**Cover letter of manuscript egusphere-2025-4591 “High-Speed Infrared Thermography for Measuring Flash Temperatures in Sheared Fault Gouge Analogues”**

Reviewer #1: Lu Yao

Reviewer #2: Monica Barbery

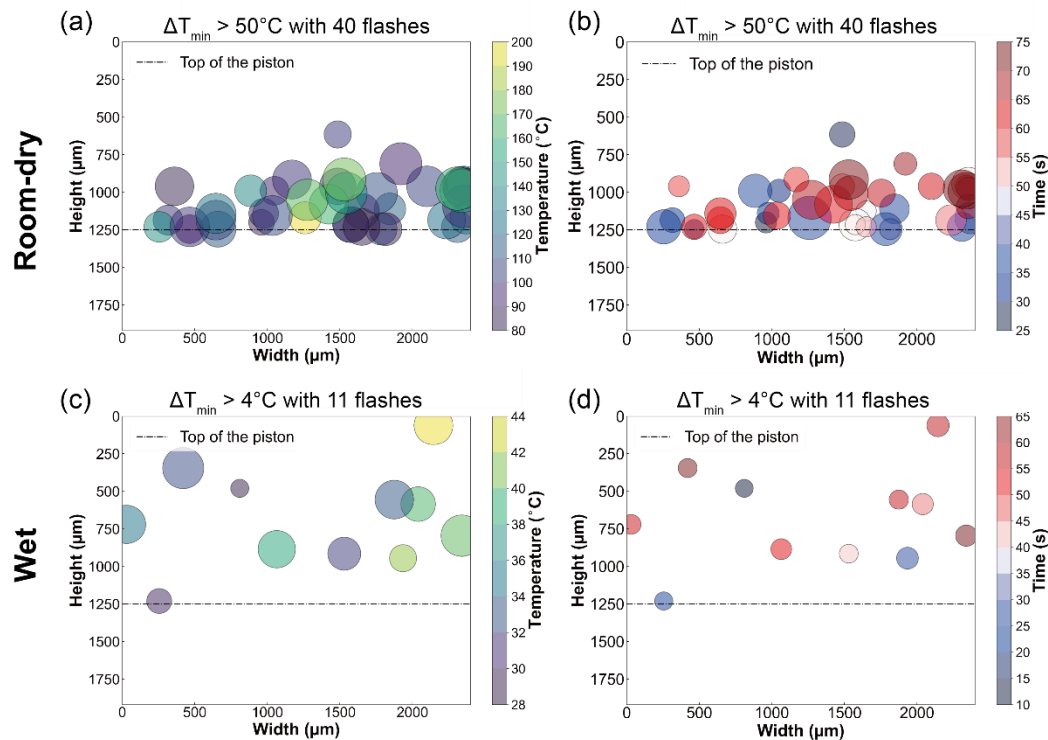
(2) Line 331: Just to confirm: larger dots indicate higher temperature rise in a & c, and later occurrence in b & d, right? Also, is the unit of time on the Y-axis of panels b and d correct?

Figure 7 b: There are 3 spots with times close to 50s that are very hard to notice unless you look very closely, and 3 more I was unable to locate (I could only find 37 out of 40). A thin black line around these spots could perhaps help the reader see these spots more clearly. A scale bar for occurrence time (a,c) or temperature rise (b,d) could also be helpful here.

We thank Dr. Yao for checking these details. Yes, the first interpretation is correct. We have corrected this in the main text. Regarding the second question, the time units on the Y-axis of panels (b) and (d) are correct; both experiments (r230 and r251) lasted 75 seconds during the shearing stage.

We thank Dr. Barbery for the suggestions. We have modified Figure 7 accordingly to increase the clarity as shown below.
